Access Compliance Report

Public Rights-of-Way

(Curb Ramps)

Intersection ID: 14846	Main Street: HENLEY_PL	Cross Street: S_KINGS_DR	Location: NW
ADA ID: 324A7DEEECEE	Ramp Type: PerpDiag	Initial Pass/Fail: Fail	Overall Compliance: No
Severity Score: 25			
Codes/Mitigation Info/Possible Solution		Field Measurements/Component Compliance

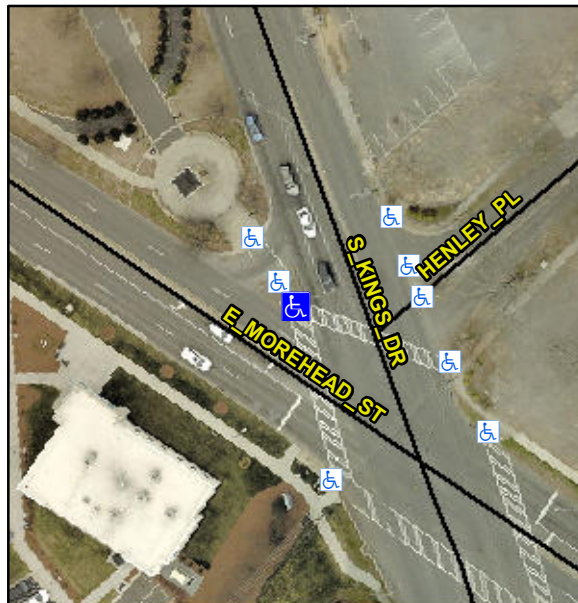
Not Found, R304.5.3

Compliance	Description	Data	Compliance	Description	Data
N/A	Ramp Length (in)	72.0	Yes	Ramp Slope (%)	5.1
Yes	Ramp Width (in)	48.0	No	Ramp XSlope (%)	8.0
N/A	Flare Type LT	N/A	N/A	Flare Type RT	N/A
N/A	Flare Slope LT (%)	N/A	N/A	Flare Slope RT (%)	N/A
N/A	Flare Traversable LT?	N/A	N/A	Flare Traversable RT?	N/A
N/A	Landing Length (in)	N/A	N/A	DWS Provided?	N/A
N/A	Landing Width (in)	N/A	N/A	DWS Contrast?	N/A
N/A	Landing Slope (%)	N/A	N/A	DWS Length (in)	N/A
N/A	Landing X Slope (%)	N/A	N/A	DWS Full Width?	N/A
N/A	Landing Curb? (Y/N)	N/A	N/A	DWS Offset (in)	N/A
N/A	Shared Landing?	N/A			
N/A	Gutter Ponding?	N/A	N/A	Gutter Slope (%)	N/A
N/A	Gutter Lip Ht (in)	N/A	N/A	Gutter X Slope (%)	N/A
N/A	Painted X Walk1?	Yes	N/A	Painted X Walk2?	Yes
	X Walk 1 Direction	To SW		X Walk 2 Direction	To SE
N/A	X Walk 1 Width (in)	105.0	N/A	X Walk 2 Width (in)	82.0
	X Walk 1 Slope (%)	0.8		X Walk 2 Slope (%)	2.1
	X Walk 1 X Slope (%)	6.0		X Walk 2 X Slope (%)	4.2

Remove & Replace Curb Ramp With Two New Directional Ramps or Equivalent.
